# BCA ASSESSMENT REPORT

*16-20 Old Castle Hill Road, Castle Hill*

Project number: 250287  
Revision: BCA 2.0  
Date: 17 December 2025

Figure 2: Ground Floor Fire Compartments show the fire walls to provide residential, retail tenancy and loading dock / car park fire compartment.

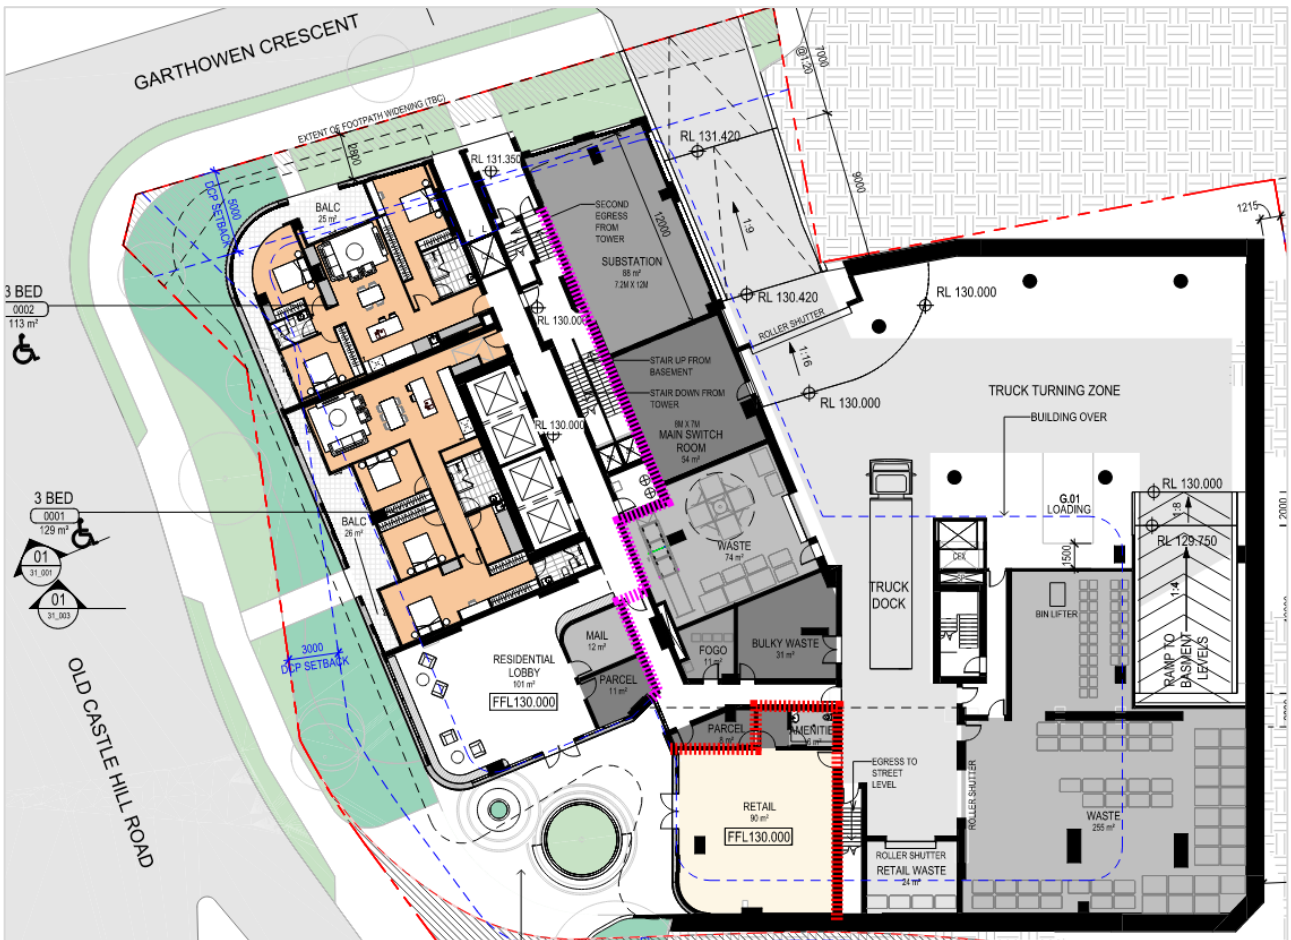
Separation of classifications in the same storey and separation by fire walls shall be achieved on the Ground Floor in accordance with BCA Clause C3D8, C3D9 & C3D10. Refer to Part 2.6 Fire Compartments for the preliminary assessment of fire compartments. This assessment is to be reaffirmed at Construction Certificate stage once holistic fire compartment drawings are available for assessment.

On the Ground Floor around the residential lobby and retail tenancy, the external walls and openings in different fire compartments will be protected in accordance with Clause C4D4 & C4D5. External walls shall have FRL not less than 60/60/60. Lobby and retail glazing shall be fixed closed and be protected with wall-wetting sprinklers as per C4D5. Fire rating and protection of openings is a design element that will require detailed assessment and specification at Construction Certificate stage.
